OBJECT	DATE	NUMBER
Systems Turnkey module malfunction	10/9/79	007
PRODUCT AFFECTED All systems turnkey module PCBA's P/N 200372-01

200374, SHEET 1. ZONE 7C REVISE:

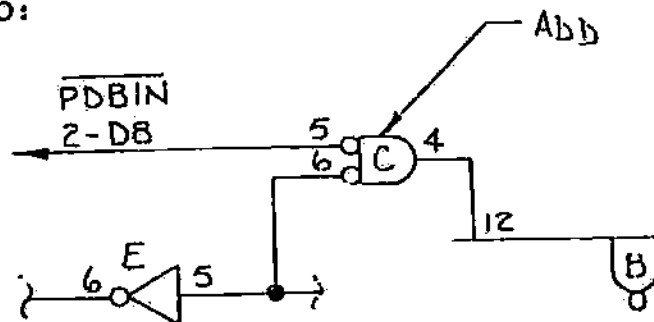
The new systems turnkey module P/N 200372-01, will disable the prompts if an I/O instruction is executed from prom location. This means that the systems turnkey module will not function properly with certain programmed prompts. To avoid this particular malfunction, you must install the following modifications:

REVISE SCHEMATIC DRAWING #200374 AS FOLLOWS:

FROM:

TO:

200374, SHEET 2. ZONE D8

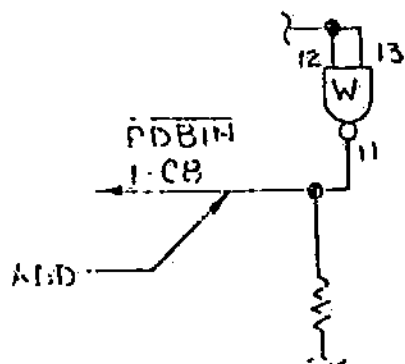
ADD:

SYSTEMS TURNKEY MODULE

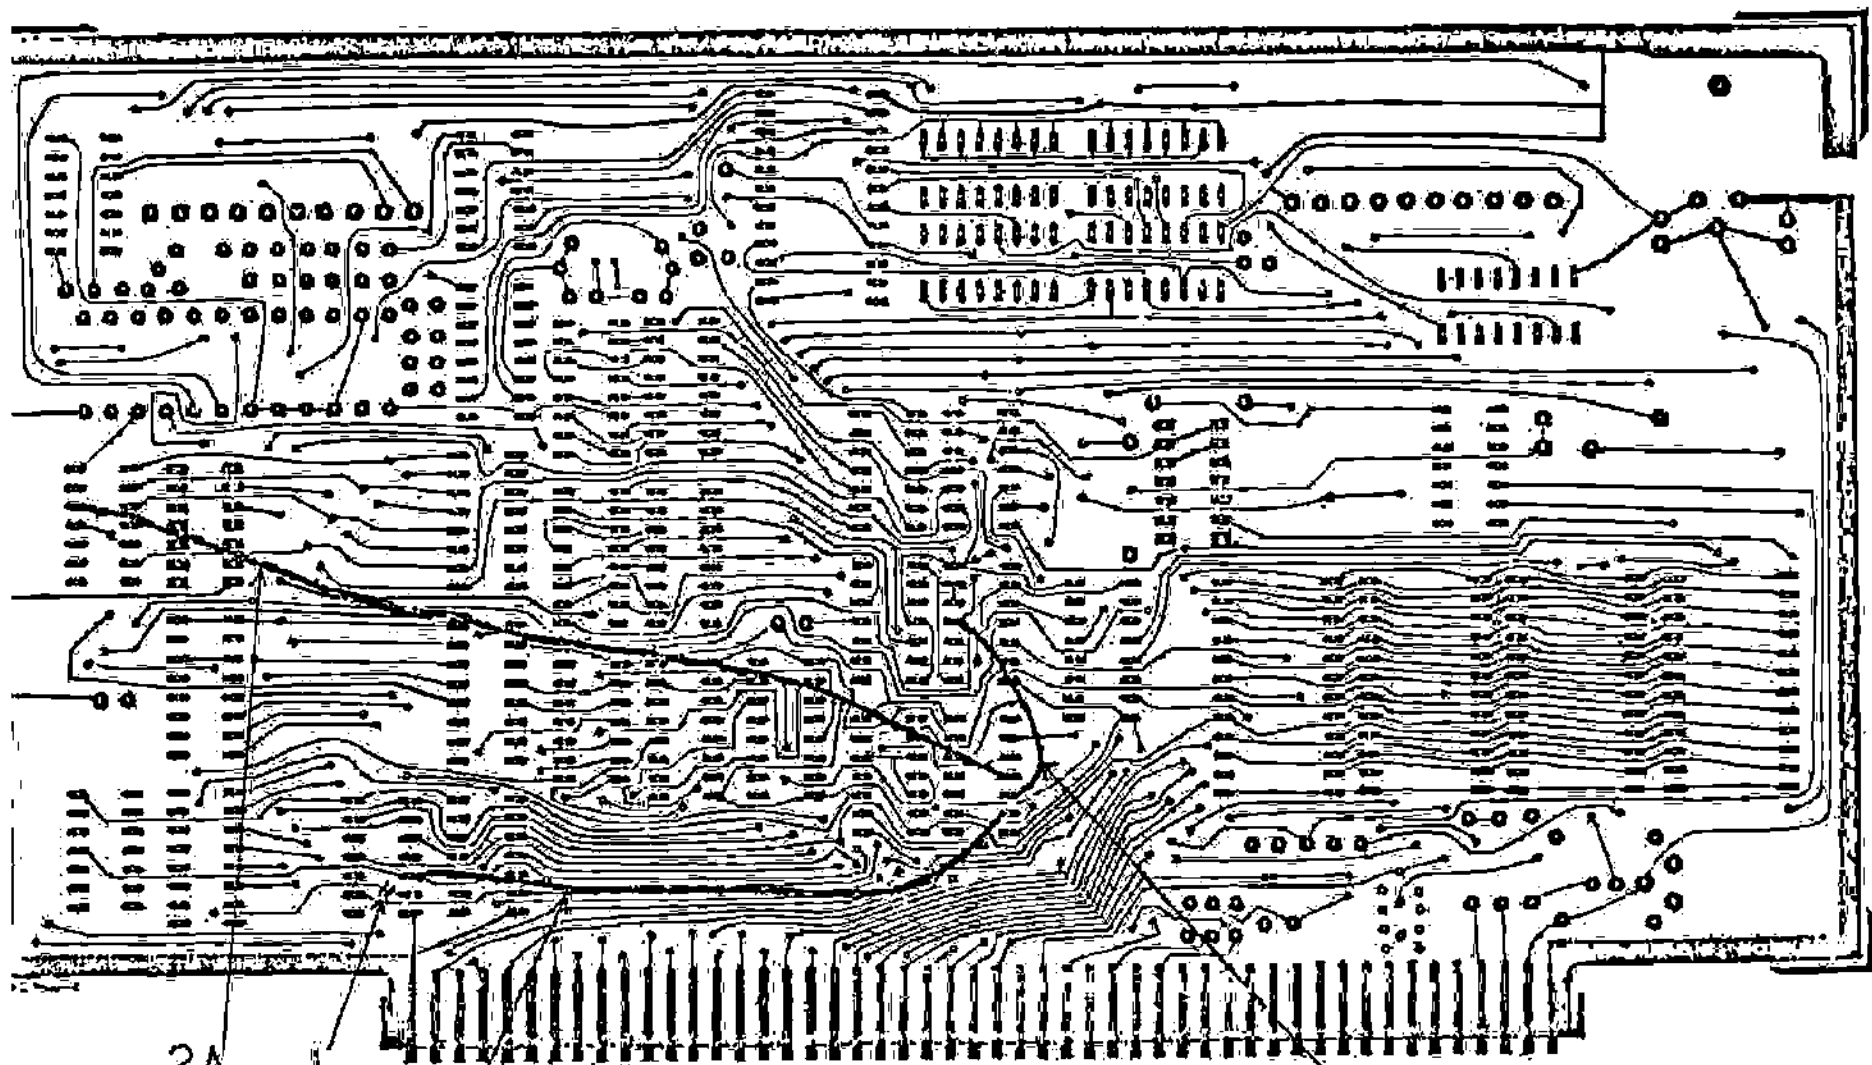
1. Cut etch at I.C. "E" pin 6 on the back side of the board.
2. Install the following jumpers using 30 awg solid insulated wire P/N 510023-030.
 - A) I.C. "C" pin 4 to I.C. "B" pin 12
 - B) I.C. "C" pin 5 to I.C. "W" pin 11
 - C) I.C. "C" pin 6 to I.C. "E" pin 5
